Re: **Tronox LLC (TRX)**
NDEP Facility ID #H-000539
Nevada Division of Environmental Protection (NDEP) Response to:
Phase B Source Area Investigation Work Plan, Area I (Northern LOUs), Tronox LLC
Facility, Henderson, Nevada
Dated April 3, 2008

The NDEP has received and reviewed TRX's Phase B, Area I Sampling Analysis Plan (SAP) identified above and finds the document acceptable with the conditions and comments provided in Attachment A.

Attachment A

SAMPLE LOCATIONS FOR LOU #1 (FORMER) TRADE EFFLUENT SETTLING PONDS		
Phase B Source Area Investigation Tronox Facility Henderson, Nevada		
SCALE: AS SHOWN	DATE: 4/3/2008	PROJECT NUMBER: 04020-023-430

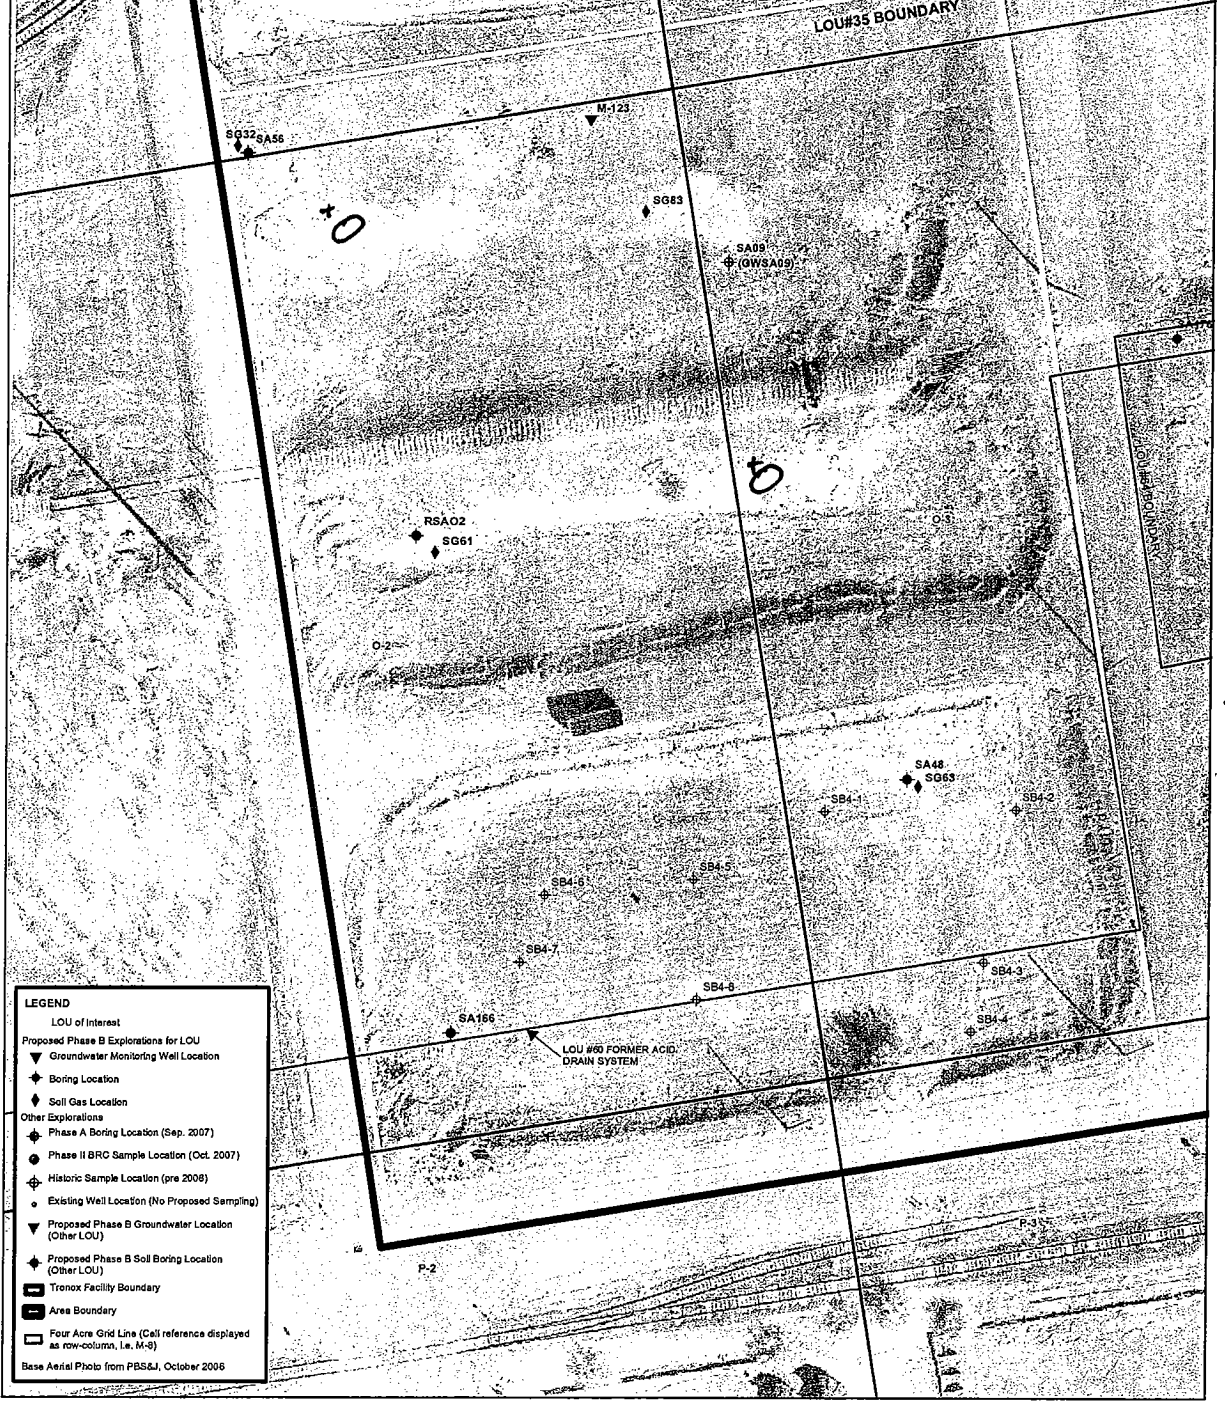
- 2. SA79 should be relocated within the white-stained area located approximately 100 feet west-northwest from the originally proposed location of SA79.

- 3. RSAI2 should be relocated within the white-stained area adjacent to the east of LOU 10 located approximately 230 feet north of the originally proposed location of RSAI2. This boring should be relocated to better characterize LOU 10.

- 4. RSAI3 should be relocated to just south of LOU 10 to better characterize LOU 10.
 - e. LOU 2, Open Area South of the Trade Effluent Settling Ponds, the NDEP has the following comments:

- ii. Figure 1, the NDEP has the following comments:
 - 1. SA79 should be relocated as discussed in the above LOU 1 comments.
 - 2. RSAJ8 may be removed from the sampling plan. The NDEP believes that this boring is located too far cross-gradient from LOU 23 for characterization of this LOU.

- 3. M-84 should be replaced with well M-86 in the groundwater sampling plan.
 - h. LOU 35, Truck Emptying/Dumping Site, the NDEP has the following comments:

For: LOU 1, LOU 10, LOU 22 & LOU 23
 X = delete
 O = relocate boring
 + O = add well

(8 changes)

SAMPLE LOCATIONS FOR LOU #58 AP PLANT AREA NEW BUILDING D-1		
Phase B Source Area Investigation Tronox Facility Henderson, Nevada		
SCALE:	DATE:	PROJECT NUMBER:
AS SHOWN	4/2/2008	04020-023-430

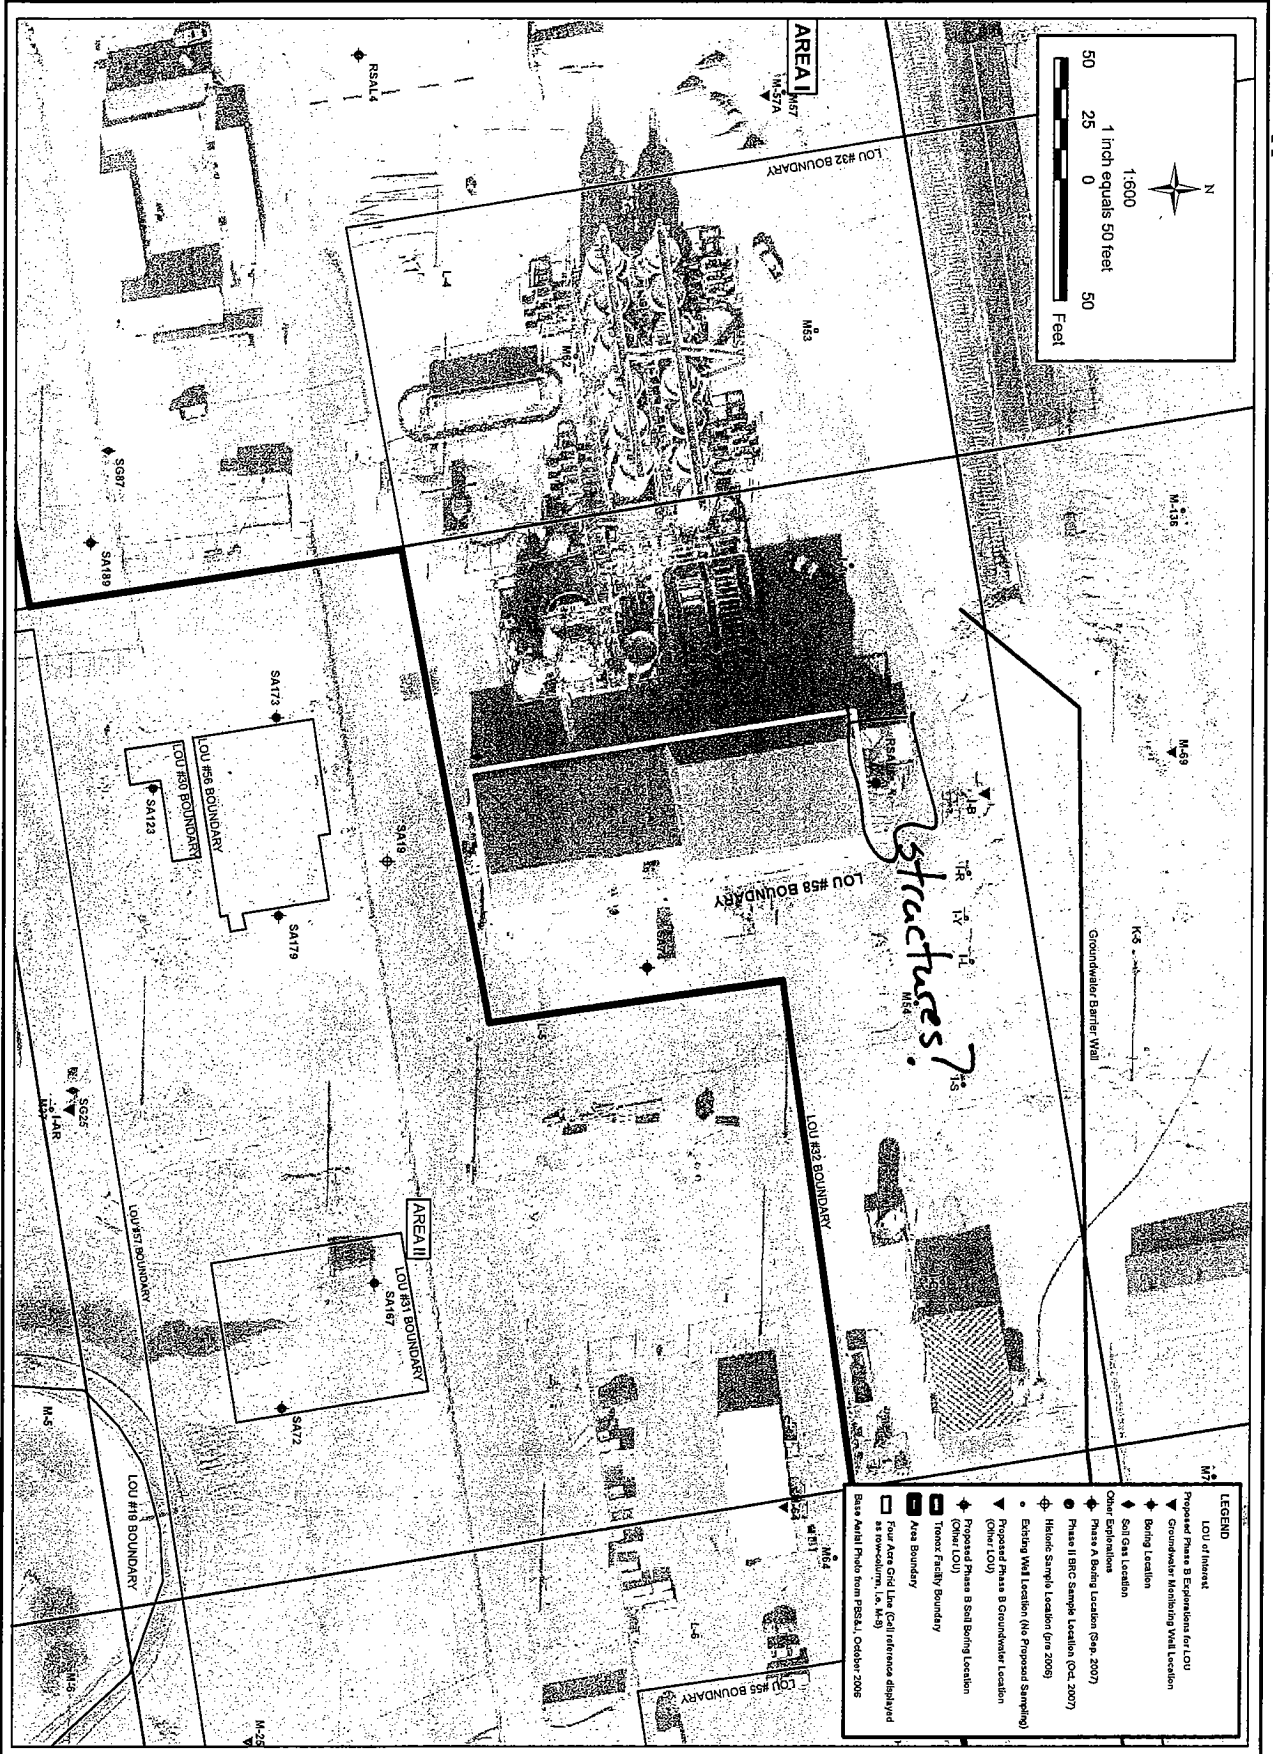
- ii. Figure 1, TRX should review the location of RSAL5 and relocate it as necessary. The aerial photograph seems to indicate the presence of structures on the proposed location for this boring.

For: LOU58

SAMPLE LOCATIONS FOR LOU #60 IN AREA I FORMER ACID DRAIN SYSTEM SEGMENT		
Phase B Source Area Investigation Tronox Facility Henderson, Nevada		
SCALE: AS SHOWN	DATE: 4/27	PROJECT NUMBER: 04020-023-430

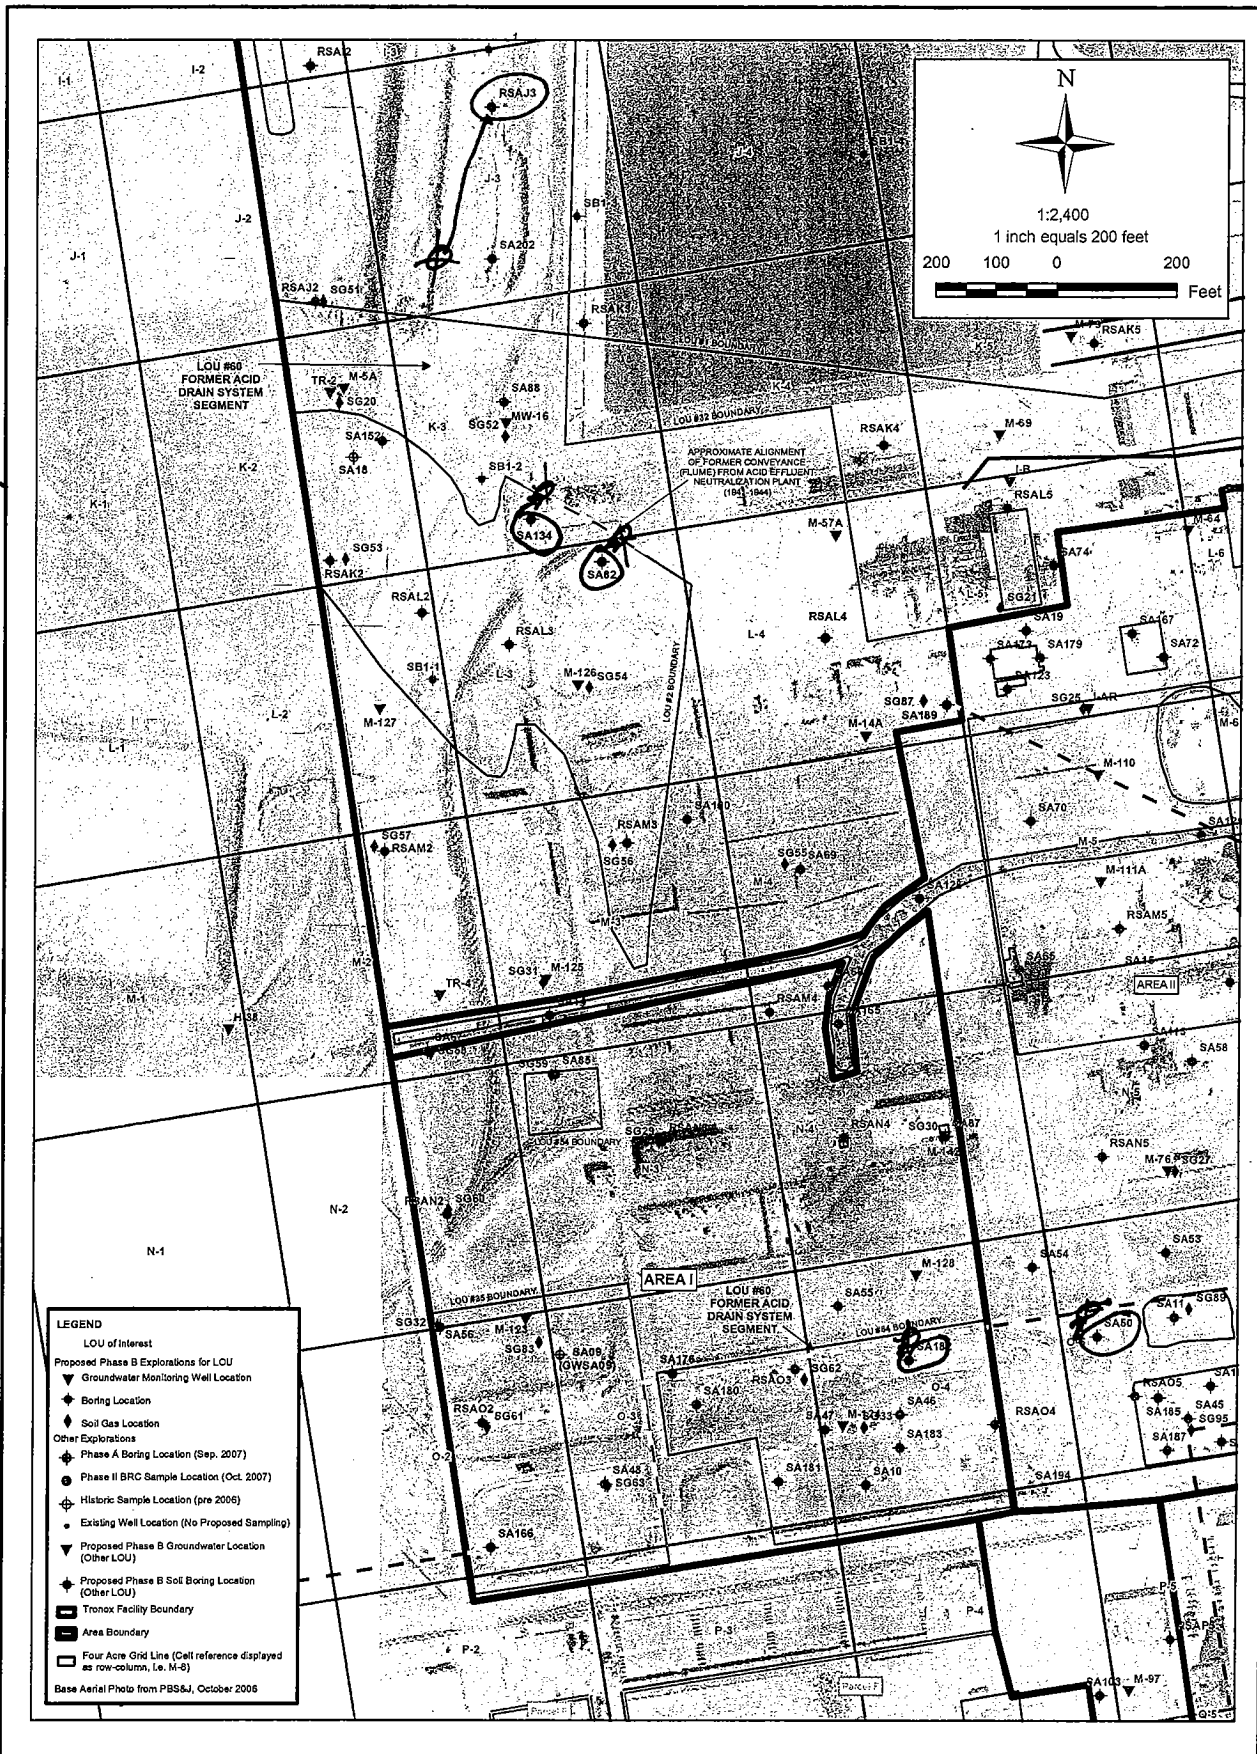
- ii. Figure 1, the NDEP has the following comments:
 1. Borings RSAL4, SA50, SA82, SA134, SA166, and SA182, SA189 should be located directly over the former acid drain by using a backhoe or other similar equipment to locate the drain. NDEP requests that TRX locate the borings over joints in the former acid drain system if discovered.

2. RSAJ3 should be relocated to the outlet of the former acid drain system.
 3. An additional boring should be located to the west of the outlet of the acid drain system approximately the same distance as SA202 is from the outlet to the east.

For LOU 60 (4 Area I changes
